N19 SHANNON AIRPORT ACCESS ROAD IMPROVEMENT SCHEME

**Preferred Option
Public Consultation
3 December 2021**

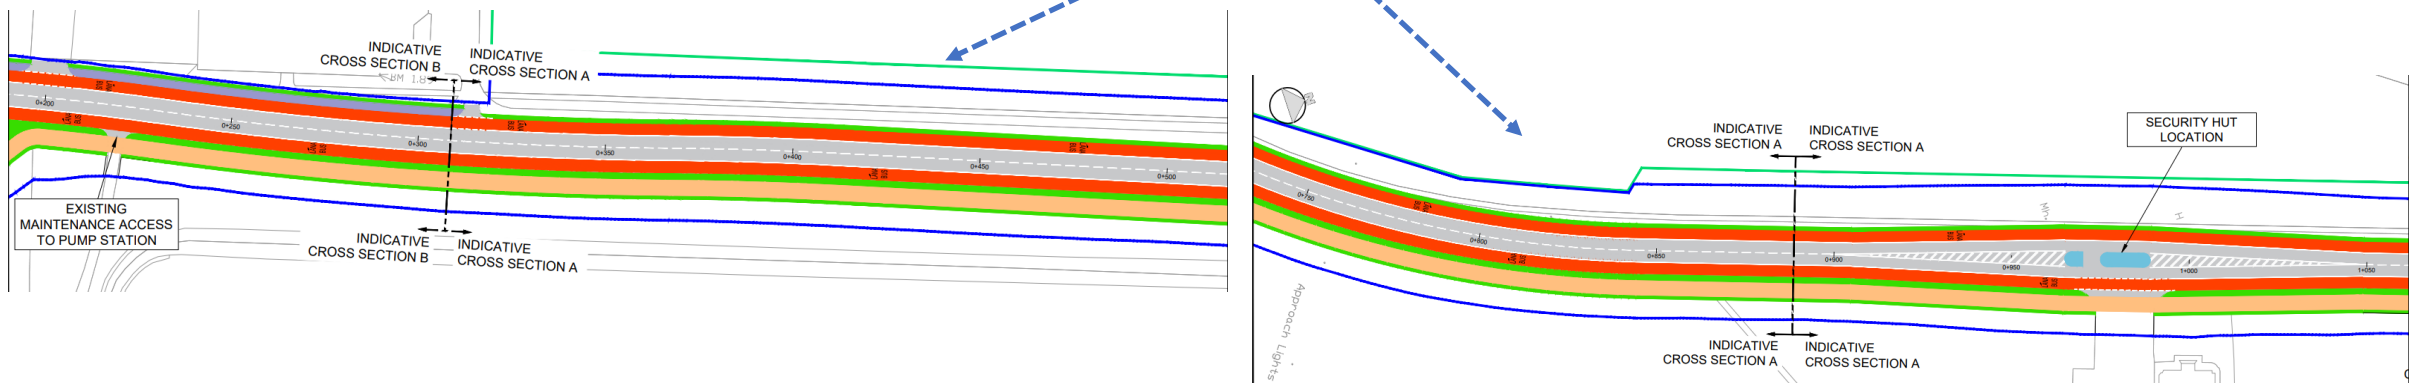
We note that the suggested positioning of proposed cycle/pedestrian pathway is below the River Shannon embankment.

In our December 2020 Submission, we had suggested using the existing pathways and the river embankments to create a combined pedestrian and cycleway close to the N19. Doing so would make use of existing river walks, Shannon Free Zone pedestrian and running tracks, and the existing river embankments which follow the line of the N19. It would also provide an opportunity to start a greenway from the airport doors, making the River more accessible and visible to those arriving/departing Shannon Airport.

Given that the flood relief works are currently underway, we would request that the selected route be linked in some way to the creation of a walkway/cycleway along the top of the embankment and that usage by new transport options, such as eScooters, be accommodated in the final selected option.

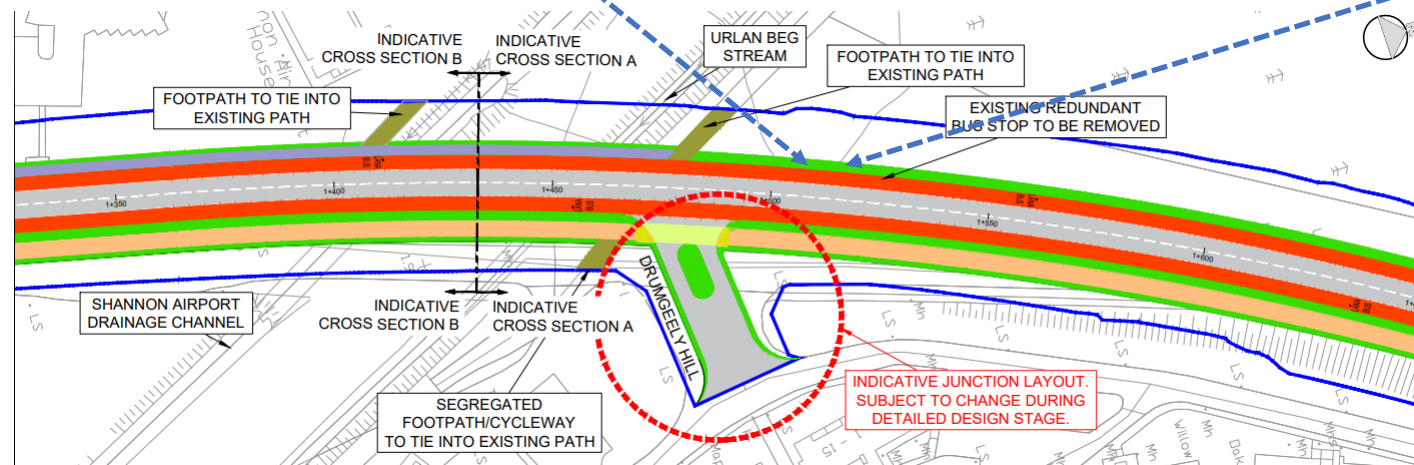
Map N19-SAARS-DR-CW-04-0011 does not make any reference to the existing pedestrian crossing between the Drumgeely Apartments and the SFZ. This is an important crossing point particularly since it connects directly to a recently installed pedestrian pathway into the SFZ. It should be maintained, particularly since the Chamber's previous suggestion of an overhead pedestrian walkway in this area has not been included in the preferred option.

There is also an argument for enhancing the bus stop in this area as it is closer to SFZ pathways and residential areas across the road with the potential to offer greater footfall for public transport. In contrast, the proposed bus stop location (which is actually in place) near the Westair Hangar is further away from both residential and business areas.

Existing pedestrian crossing should be maintained to encourage use of pathways to SFZ

Enhance rather than eliminate existing bus stop to encourage access for SFZ and residential pax.

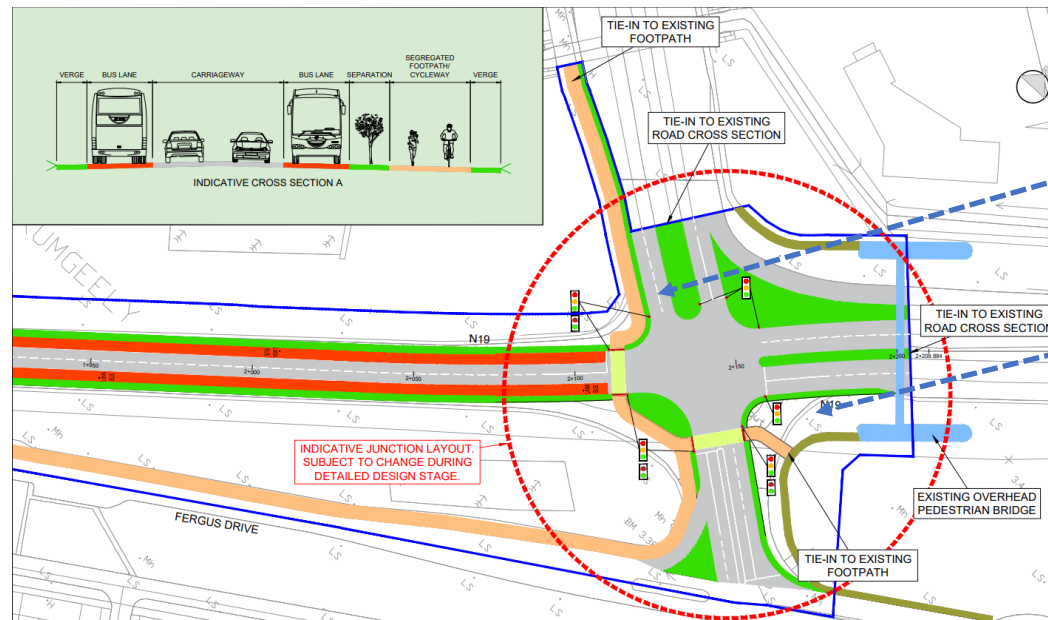
Map N19-SAARS-DR-CW-04-0012 proposes traffic lights and pedestrian crossings to replace the existing Drumgeely roundabout main entrance/exit to the SFZ. This is based on the assumption that traffic lights will be more effective in managing traffic flows at peak travel times. Without access to the transport analysis (referenced but not available on the public consultation website) it is not possible to make an informed judgement on this proposal. Great care is needed with this change given the patterns and volume of traffic during early morning and late evening rush hour waves.

The existing pedestrian bridges are well used by commuters to and from the SFZ. Healthy walking pathways are also being introduced around the Zone including in this area between Rineanna House and the sluice gates referenced on the map. Residents have also started to “do the bridges” as a healthy walking route with a roughly 2km circuit from the bridge at this location to the next one (town centre side of SFZ) and back. Alignment of the crossings and pathways with the pedestrian bridge ramps will encourage greater use of these facilities.

Alignment of pedestrian/cycle crossings with existing pedestrian bridge ramps and SFZ pathways will encourage greater use
